Intel386™ EX Embedded Processor

Specification Update

August 2004

Order Number: 272873-011

1. Watchdog Timer (WDT) Bus Monitor Failure During Bus Pipeline Operation

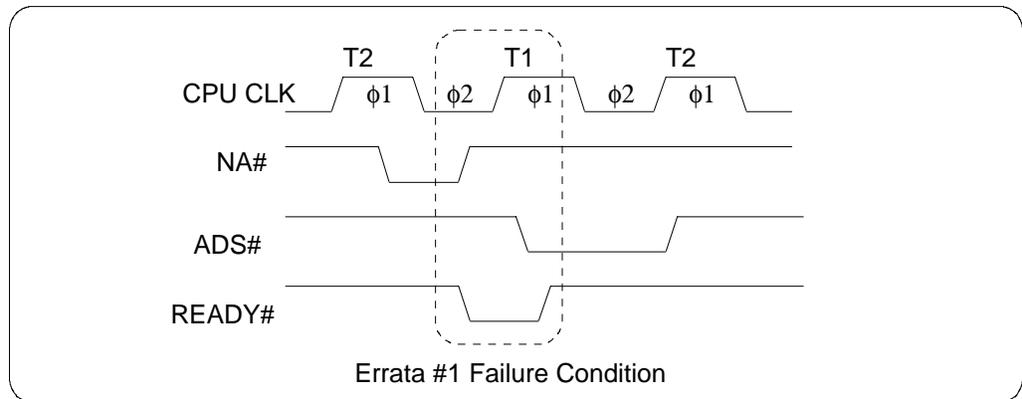
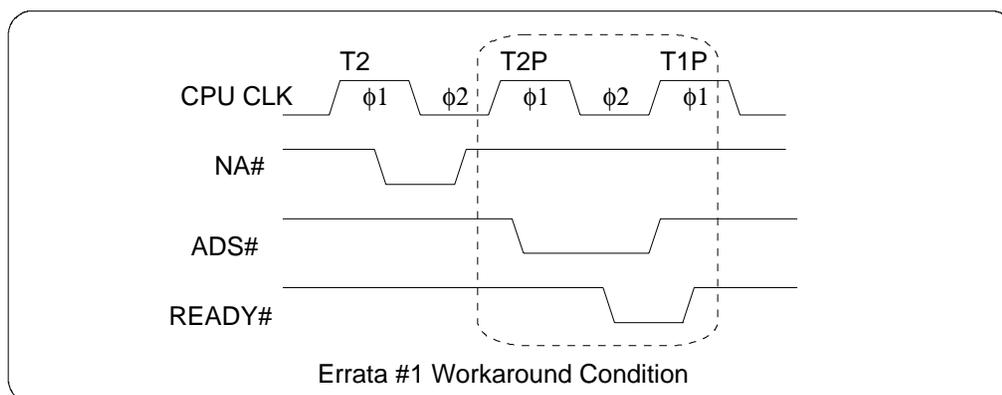
Problem: The errata applies to the WDT unit when using the Bus Monitor Mode and Bus Pipeline operation. If a pipelined bus cycle is requested at the same time the current bus cycle is completed, the WDT down counter is not reloaded or stopped. This condition means that the WDT could time-out and erroneously report a system failure. The waveform below shows the errant condition.

The errata condition is caused by the system generating READY# immediately after NA# has been requested, and a T1 cycle is generated (rather than a T2P cycle). Essentially, the system is requesting a pipelined access, but does not need it because READY# has been returned. Such a condition is not typically expected when using the pipeline feature.

Workaround: Ensure that READY# is not generated after a pipelined bus operation is requested. See the example waveform below.

30. HLDA Inactive To HOLD Active Arbitration Could Improperly Float The Bus

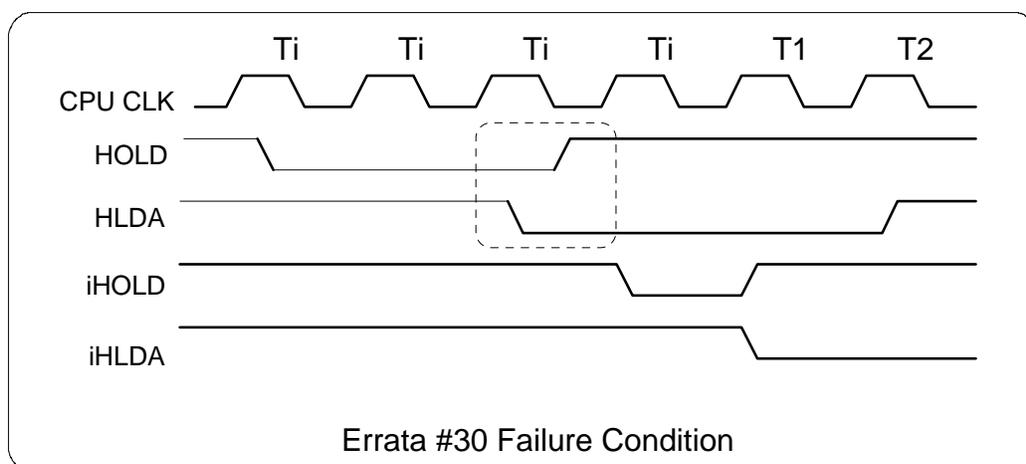
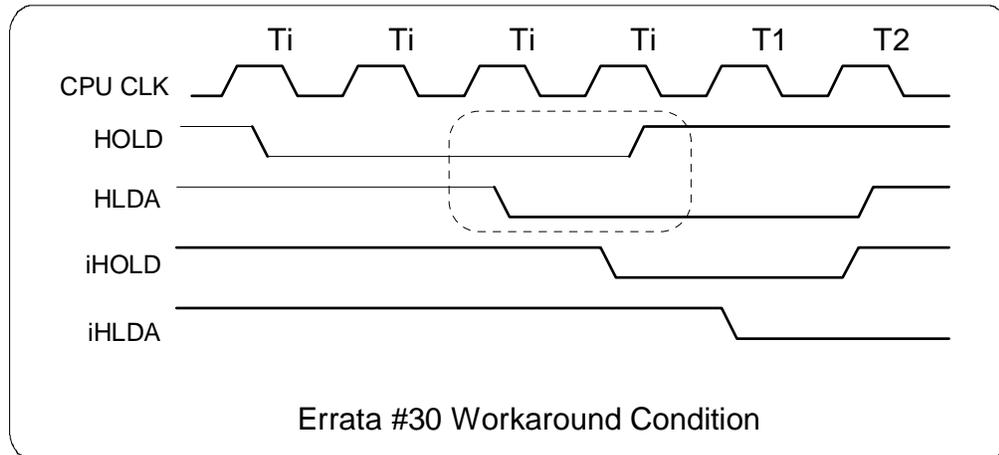
Problem: In a HOLD/HLDA cycle the HOLD signal must not be re-asserted until after HLDA is returned inactive. If, however, HOLD is asserted in the same T-state that HLDA goes inactive a problem may occur where the bus arbiter relinquishes control to the core and at the same time floats the bus by asserting the HLDA pin. The following waveform shows the conditions that cause this error. The signals iHOLD and iHLDA are internal signals and represent the HOLD input to the core and the HLDA output from the core (equivalent to the HOLD and HLDA signals on a Intel386™ SX processor). In this diagram a T1 occurs because a request was pending by the core during the previous HOLD cycle. One T-state after the arbiter releases the bus (HLDA = 0) it removes its iHOLD, and then the core removes iHLDA. As soon as the iHLDA is released, the T1 state starts. However, because of the timing of the next HOLD request, the bus arbiter re-asserts iHOLD and HLDA even though the core has not asserted iHLDA. The result is that the core continues to run its bus cycle and, at the same time, the bus arbiter has floated the external bus. It is also possible for the following to occur when HOLD/HLDA arbitration is at issue: HOLD is driven active during the T1 or Tw of a valid bus cycle. The processor begins the next bus cycle and generates HLDA. HLDA is active for only one T-state. ADS# is extended through the bus cycle. The alternate bus master sees the HLDA and performs its bus activity. HOLD is then driven inactive and the bus is returned to the Intel386™ EX Processor. At this point there is bus contention.

It is also possible for the following to occur when HOLD/HLDA arbitration is an issue: HOLD is driven active during the T1 or Tw of a valid bus cycle. The processor begins the next bus cycle and generates HLDA. HLDA is active for only one T-state. ADS# is extended through the bus cycle. The alternate bus master sees the HLDA and performs its bus activity. HOLD is then driven inactive and the bus is returned to the Intel386™ EX Processor. At this point there is bus contention.

Workaround: Synchronize the external HOLD request such that it does not go active until at least one T-state after HLDA is inactive. See the following example waveform.

Another workaround is to delay the generation of HOLD until the last T2-state of a valid bus cycle (excluding refresh cycles or INTA cycles).

Figure 3. HOLD with Short REFRESH Interval

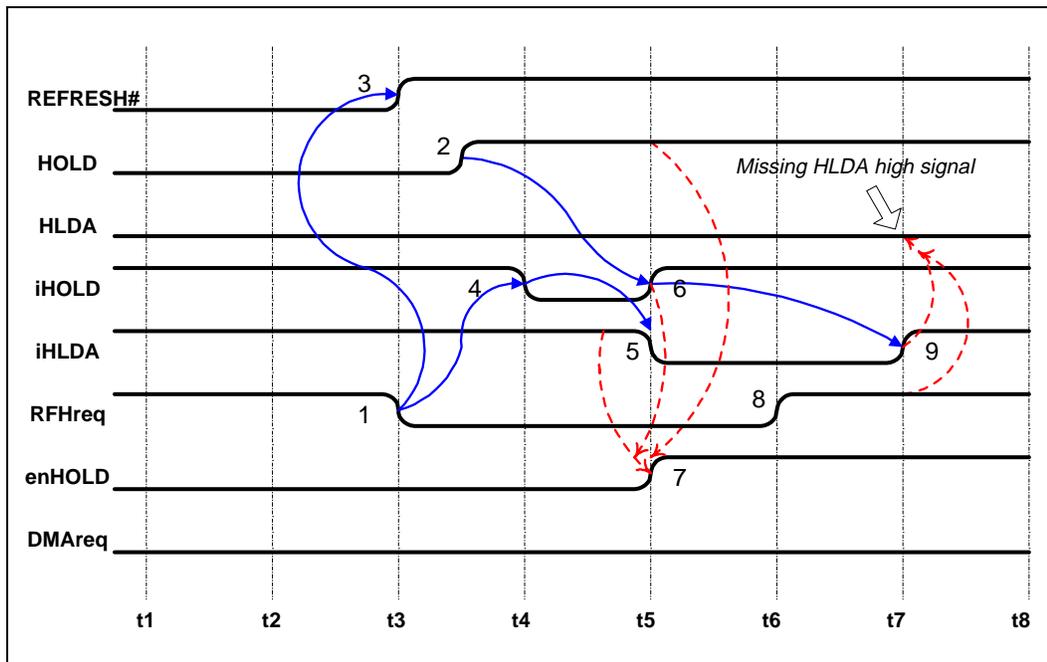
Figure 3 shows Condition #1a where an external HOLD and refresh request conflict can occur. The table below describes each signal name used:

Figure 4. Quick HOLD Assert and Deassert with Slow REFRESH Interval

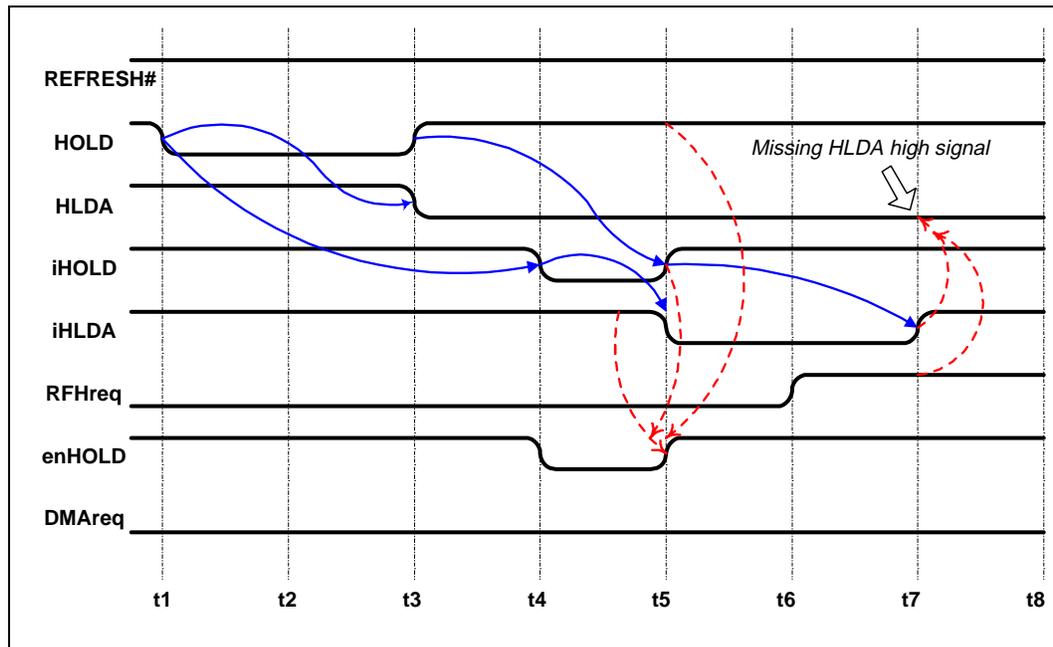
- b. HOLD is removed and reasserted within one bus cycle. Refer to Figure 4. This condition will cause the problematic window with fast iHOLD deassertion (t4) and assertion (t5). Note that if HOLD is deasserted because of pending REFRESH and reasserted again within one bus cycle, the problem will not occur since the iHOLD signal is never deasserted due to refresh. The reassertion of the HOLD would then be serviced upon completion of the refresh.

Figure 5. DMA, HOLD and REFRESH with Normal Interval

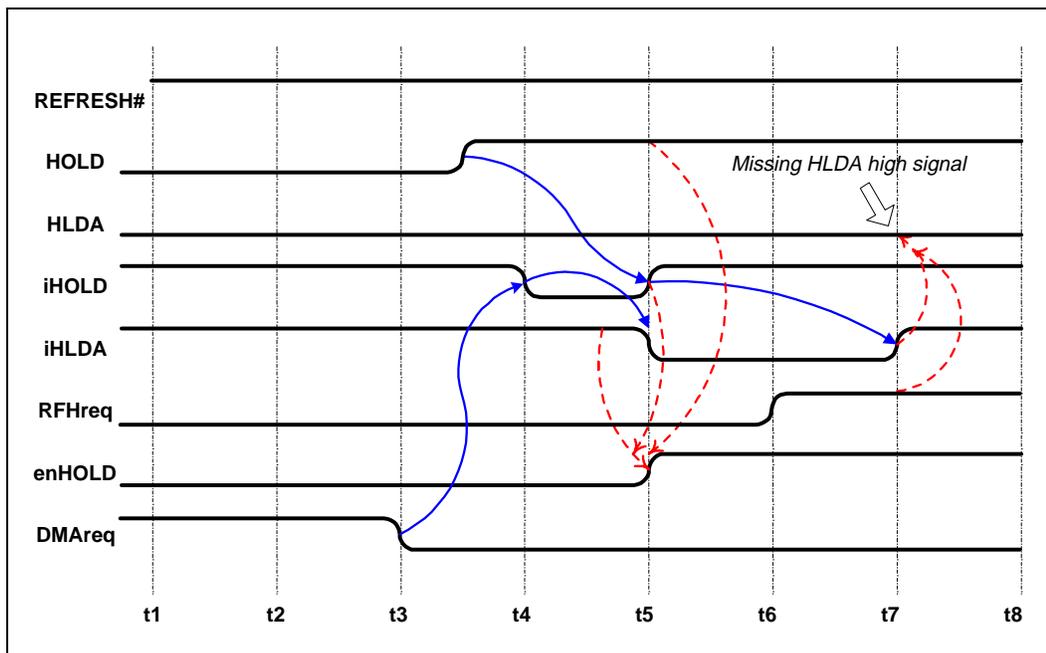
For the errata to occur, HOLD must be asserted asynchronously at any cycle such as in an idle cycle. Refer to Figure 5. Termination of DMAREQ at time t3 with assertion of HOLD at time t4 creates the problematic window. If there is a refresh request at time t6, the HLDA is blocked and will not go active at time t7. If HOLD is synchronized at the beginning of a new valid bus cycle (except for REFRESH), HLDA will always be asserted since the problematic window will not occur.

Note: DMAREQ is a signal internal to the processor. This signal is not always within the user’s control and could be internally deasserted, such as in autoinitialize mode. To avoid issues with this type of situation, it is recommended that the user deassert the external request DREQ after the last transfer has completed. It is further recommended that DREQ only be deasserted after a valid DMA acknowledge (DACK# goes low) has been returned. If a DREQ is held active and then deasserted during or shortly after the autoinitialize sequence, the problematic window can be induced and cause the errata to occur. See errata #28 for additional details on DMA programming restrictions.

Assert HOLD only after a valid ADS# has been asserted signifying a new, valid bus cycle (use ADS# to qualify HOLD). See the Intel386 EX Embedded Microprocessor User's Manual for explanation of valid bus cycles.

Workaround 2: Deassert HOLD if HLDA is not asserted within the worst case HOLD latency. This can be implemented with external logic that times-out if a HLDA signal is not asserted after the hold latency interval. Note: Slow deassertion of HOLD can increase refresh latency. The user should make sure that the errata is not induced because of late HOLD deassertion when refresh is pending. Added refresh latency can increase the potential for overlapping refresh requests (causing the error). In this workaround, HOLD should be qualified with the ADS# signal. This entails deasserting HOLD if a HLDA has not been returned and no valid ADS# signals have occurred within the time-out period for worst case HOLD latency.

Figure 6. Two DMA Channels in Cascade Mode with Internal RCU Anomaly

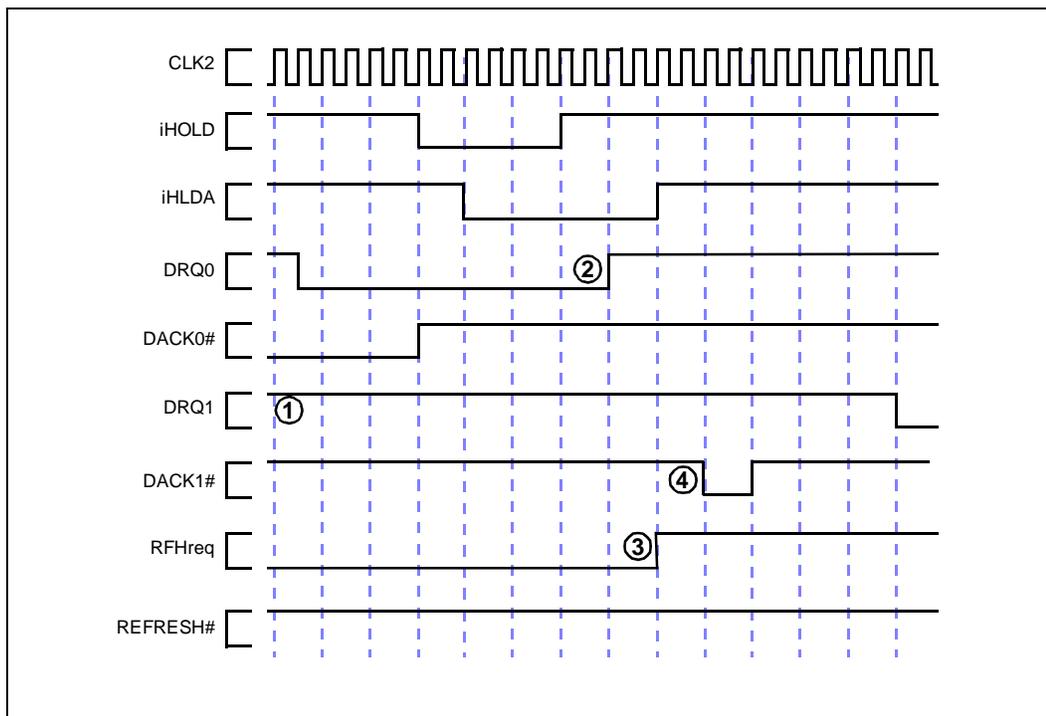
This anomaly is shown in [Figure 6](#) (internal signals used in the diagram are described in the table below). Both DMA channels are in cascade mode and Channel 1 is programmed to have the lowest priority.

The lower priority DMA channel requests the bus by asserting DRQ1 (see 1 in Figure 6). The higher priority channel requests the bus by asserting DRQ0 before the iHLDA has returned from the core (see 2 in Figure 6).

While the Bus Arbiter Unit is in the process of arbitrating priorities between the DMA channels, an internal refresh request signal (RFHreq) is asserted (see 3 in Figure 6) one PH1 cycle before the DMA acknowledge is granted (DACK1# asserted - see 4 in Figure 6). This scenario confuses the bus arbiter and the DMA acknowledge is given to the *lower* priority DMA channel. The arbiter believes the acknowledge was granted to the *higher* priority channel. The DACK1# is quickly taken away from the lower priority channel due to a pending refresh request. DMA channel 1 drops its request, apparently releasing the bus for a REFRESH cycle, but the arbiter is waiting for the higher priority channel to drop its request (DRQ0); this never occurs, since the acknowledge was never granted (DACK0#), and the system hangs.

10. 272485-002, Section 6.3.6, Page 6-29, Figure 6-11.

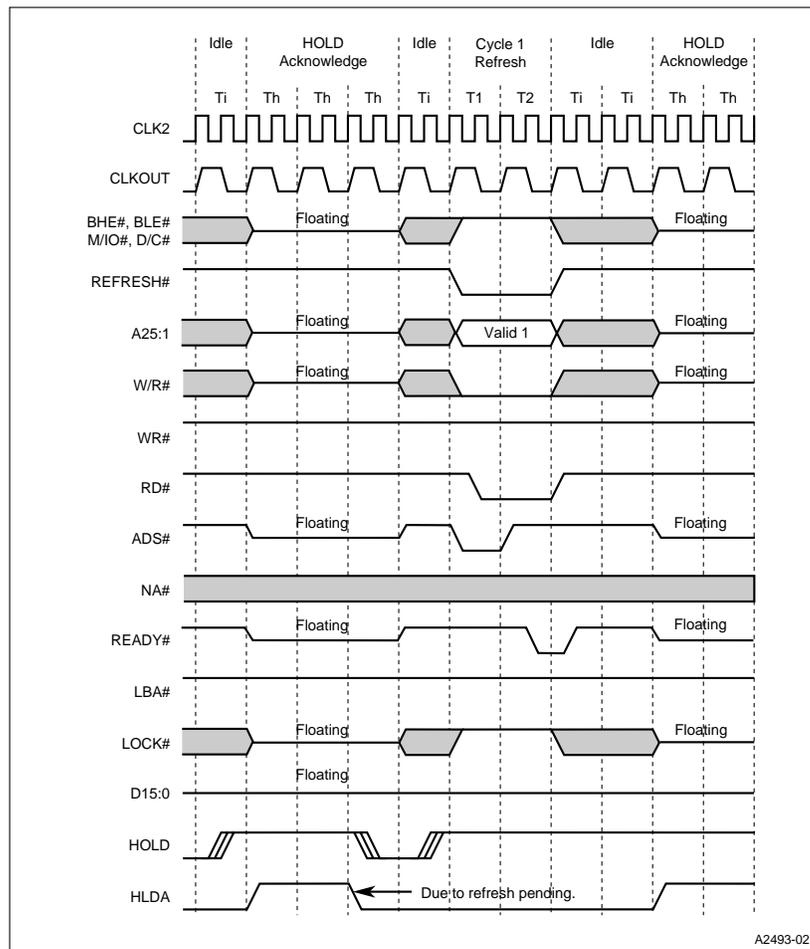
Issue: Changed “BHE#, BLE#, M/IO#, D/C#” to read “UCS#, CS6:0, BHE#, BLE#, M/IO#, D/C#”.

Figure 12. Transmit Data by Polling

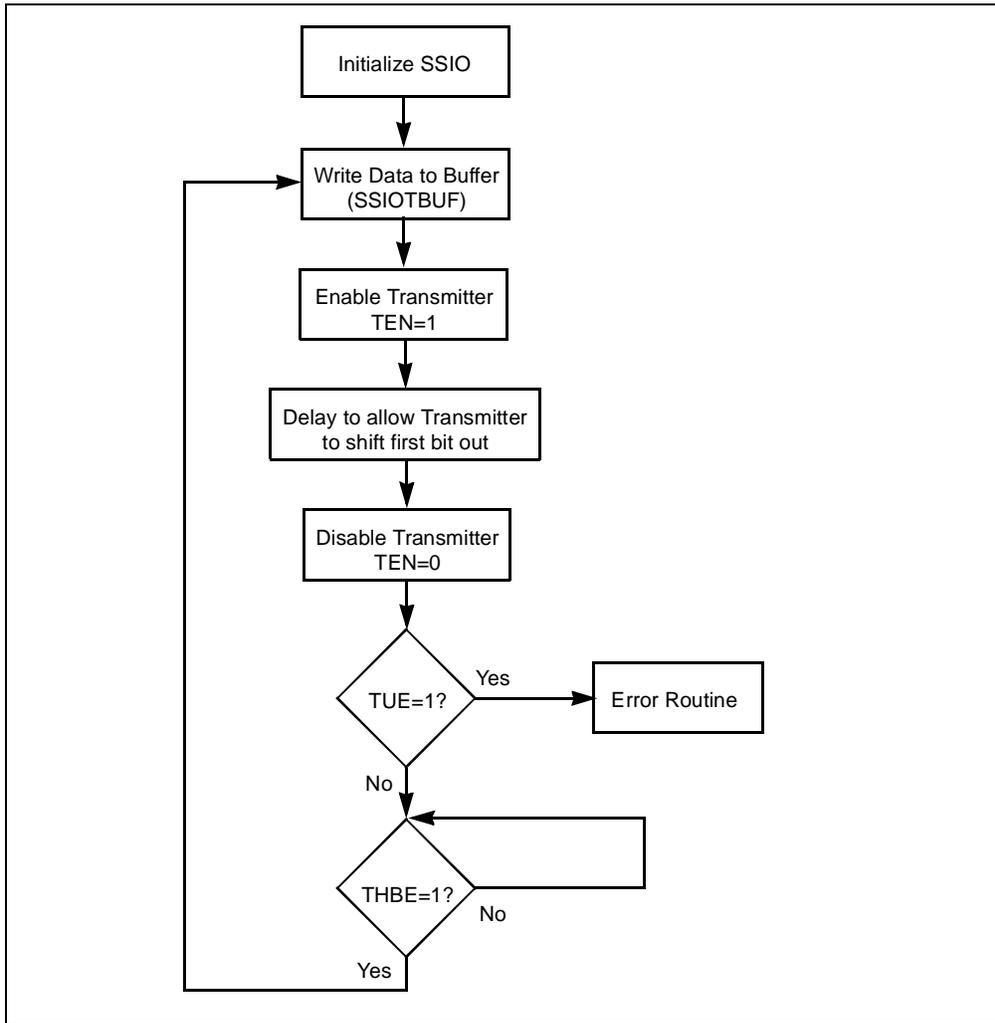
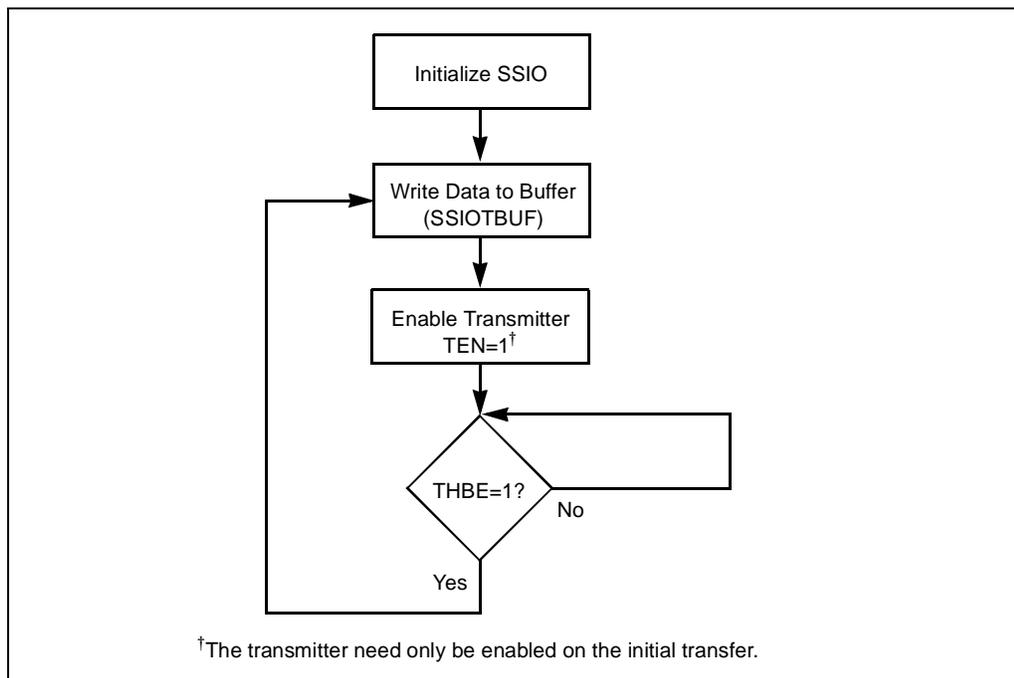
Issue: Replace figure 13-8 with Figures 13-8a and 13-8b as shown below.
